OFFICER REPORT

Application Number: P2026/0224

Site Address: Land To Rear Of 9 Maes Llwynonn Cadoxton Neath Port Talbot SA10 8AQ

Proposal: Outline application for 1.no detached dwelling and associated parking with access, layout and scale to be considered (appearance and landscaping reserved).

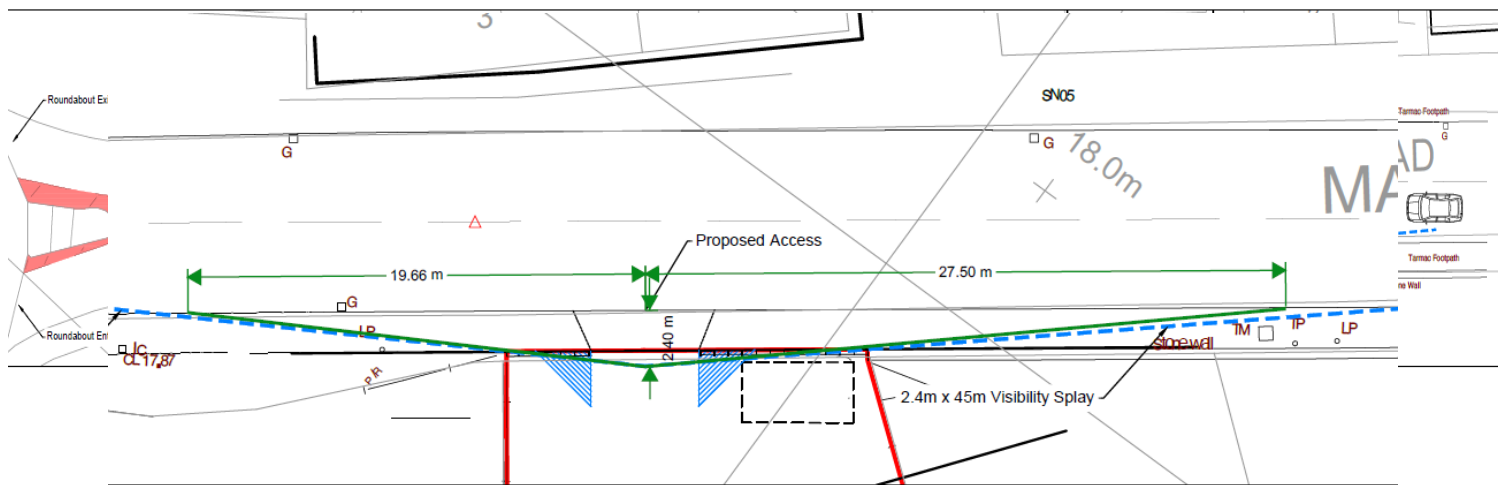
The Highway Authority has reviewed the proposal and recommends refusal for the following reasons:

1. *“A refusal is recommended on highway safety grounds as the development does not meet key highway requirements to allow for the safe access and egress to the proposed development that could also have a detrimental impact on the safe free flow of vehicles and pedestrians along the A4109. The proposed access is from an ‘A’ Classified highway that is a local distributor providing access into Neath and beyond. The visibility splay requirements in accordance with TAN 18 for a highway with a speed limit of 20mph (Table A – where road traffic speeds are not known) would be a splay of 45m in either direction with a setback of 2.4m from the edge of carriageway within which nothing over 600mm shall be erected or allowed to grow within the splay. The applicant has not demonstrated that this is achievable, even with the splays correctly drawn to the kerb line, the splays would cross over third-party land – this is not acceptable by the highway authority as the splays must be under the applicants or on the public highway to ensure the height restrictions can be maintained.*

2. *Where an access fronts a classified highway a turning facility which is independent of any parking spaces is required to allow all for the manoeuvring of vehicles to enter and egress from the site in a forward gear from the site. A turning facility with a traverse length of 8.65 meters has not been provided and there is limited scope within the site to accommodate this, and the 3 parking spaces to remain independent of the turning area. The application site based upon the indicative location of the plot cannot accommodate these fundamental highway requirements therefore a recommendation of refusal is proposed.*

3. *The highway authority requires vehicles to pass over the footway at a perpendicular angle, therefore only passing over the shortest distance of the pedestrian footpath. The requirement for vehicles to pass over the footway perpendicular to the carriageway is stated in Neath Port Talbot Council’s “Apply for a dropped kerb” highways guidance, which specifies that driveways must be at 90 degrees to the road, supported by the Highway Technical Design Guide standard vehicular crossover details. The current proposals suggest that vehicles*

would have to pass over the footway for a greater distance than required to be able to access the driveway and parking area.”

The annotated drawing above demonstrates that the required visibility splays of 45m in each direction with a setback of 2.4m from the edge of carriageway cannot be achieved at the proposed access.

It is acknowledged that the road speed has been reduced from 30mph to 20mph, resulting in a corresponding reduction in the required visibility splays. However, as demonstrated above, the necessary visibility splays still cannot be achieved within the site. Consequently, vehicles emerging from the site would have inadequate visibility of approaching traffic, giving rise to an unacceptable risk to highway safety. The proposal is therefore contrary to Policy TR2 of the adopted Local Development Plan and the guidance set out in TAN 18.
